**VILLAGE OF ALGONQUIN**  
*COMMUNITY DEVELOPMENT DEPARTMENT*

**– M E M O R A N D U M –**

SUBJECT: *Trails of Woods Creek, Rezoning to R1-E PUD, B2 PUD, Preliminary PUD and Preliminary Plat, and Development Agreement*

It is our understanding that this project will be presented to the Plan Commission this month. We offer the following comments for their consideration:

### Sheet 1

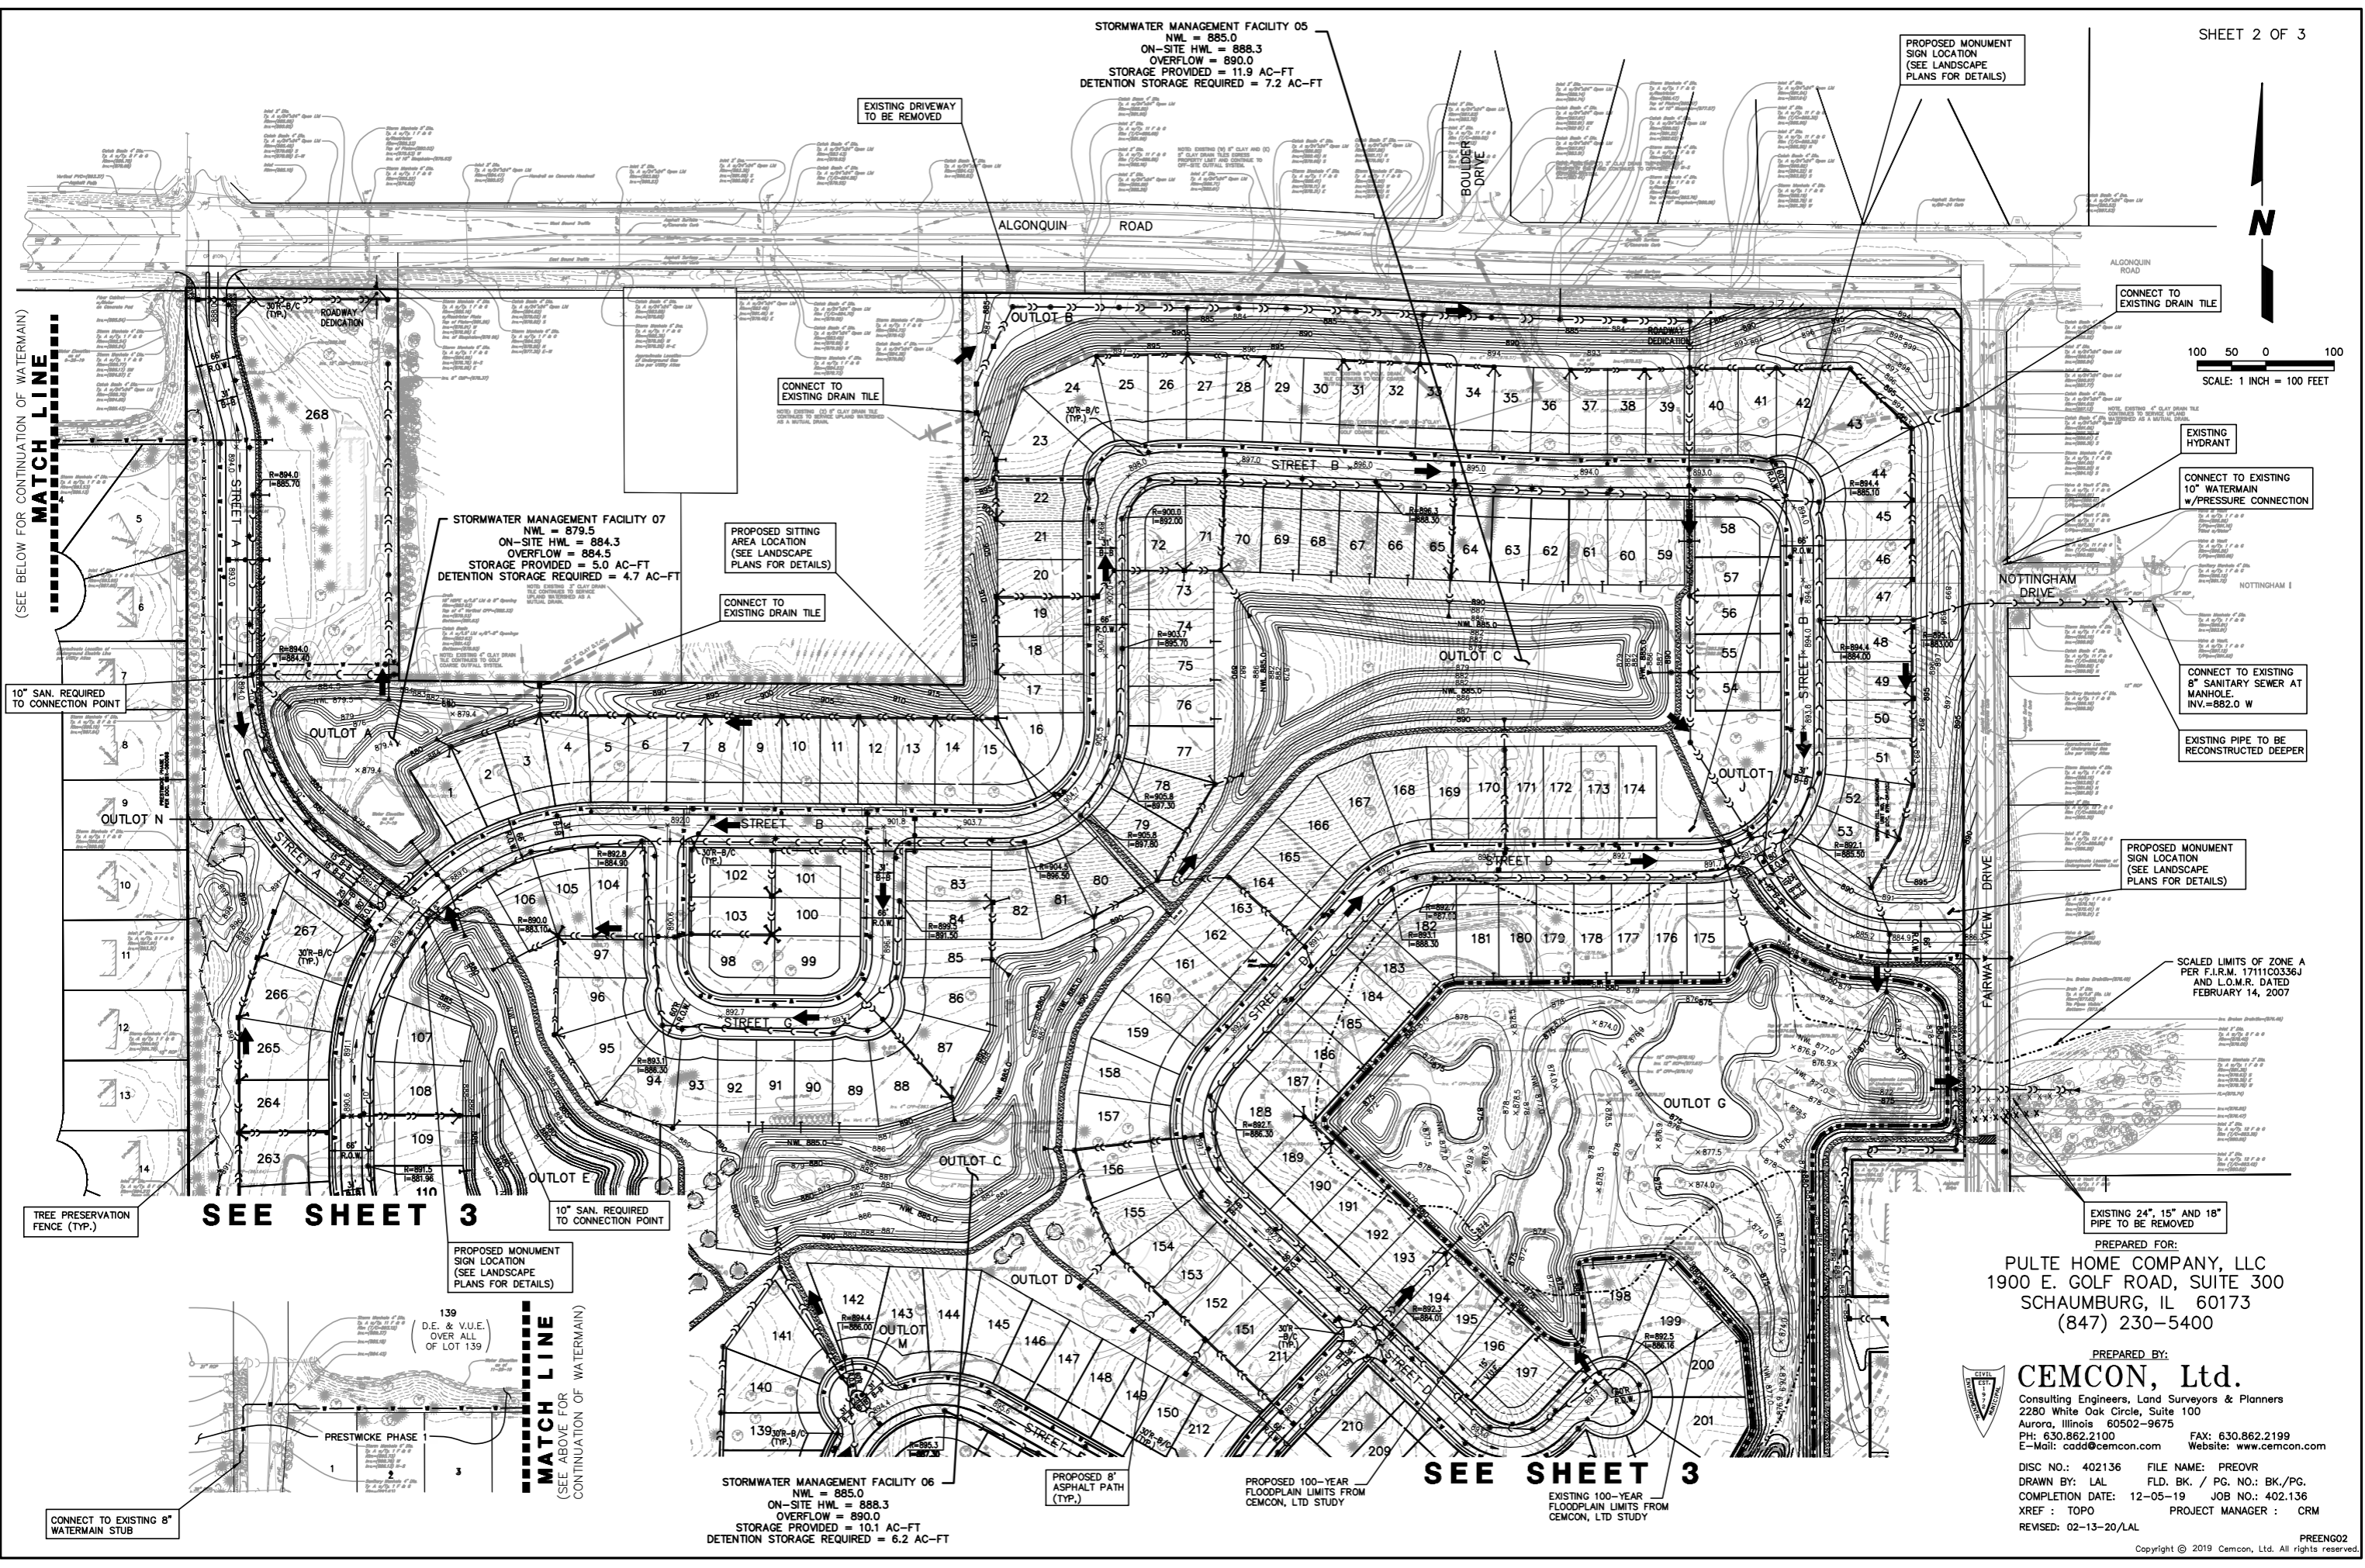
1. The site planning has been revised to eliminate the four-way intersection along Fairway View Drive at Nottingham Drive. The connection for Street H is now located 525' to the south of Nottingham Drive. We recommend that the site planning be modified to reestablish the previous four-way intersection.
